SUBJECT: REACTOR PRESSURE VESSEL PRESSURE-TEMPERATURE LIMITS (TAC 60938)

Re: Pilgrim Nuclear Power Station

AMENDMENT TO FACILITY OPERATING LICENSE

SAFETY EVALUATION BY THE OFFICE OF NUCLEAR REACTOR REGULATION
SUPPORTING AMENDMENT NO. 94 TO FACILITY OPERATING LICENSE NO. DPR-35

FIGURE 3.6.1
PILGRIM REACTOR VESSEL
PRESSURE - TEMPERATURE LIMITS
HYDROSTATIC AND LEAK TESTS

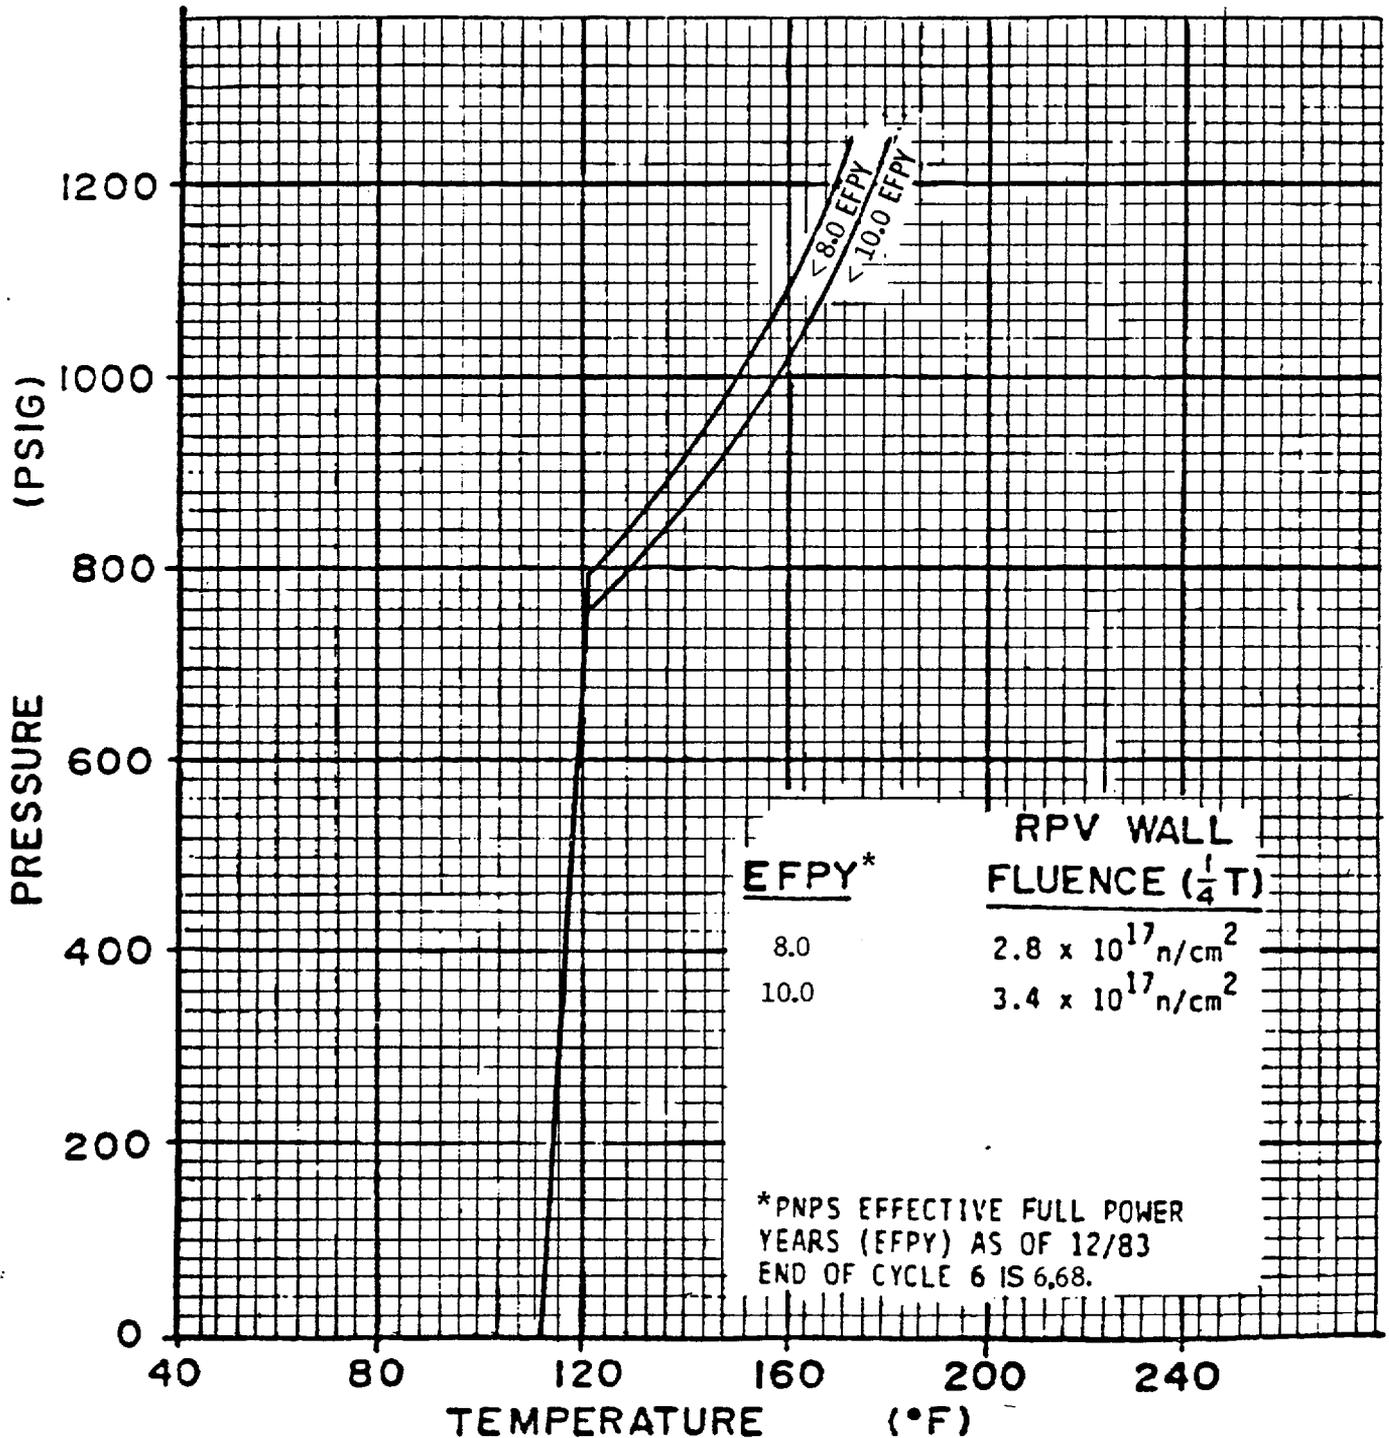
The amendment changes the pressure-temperature limit curves on Technical Specification Figures 3.6.1 and 3.6.2 to more accurately reflect the neutron exposure of the reactor pressure vessel during operation of the Pilgrim Station. The change consists of relabeling the curves from 6.68 effective full power years (EFPY) to 8.0 EFPY and from 8.0 EFPY to 10.0 EFPY.

With respect to the proposed pressure and temperature limit curves, the new calculation determined that a neutron fluence of 2.8×10^{17} n/cm² to the RPV wall (1/4 T) corresponds to 8.1 EFPY. Similarly, the neutron fluence 3.4×10^{17} n/cm² was found to correspond to 10.2 EFPY. However, for the purpose of the pressure and temperature limit curves, the neutron fluences are conservatively estimated to correspond to 8.0 and 10.0 EFPY, respectively.
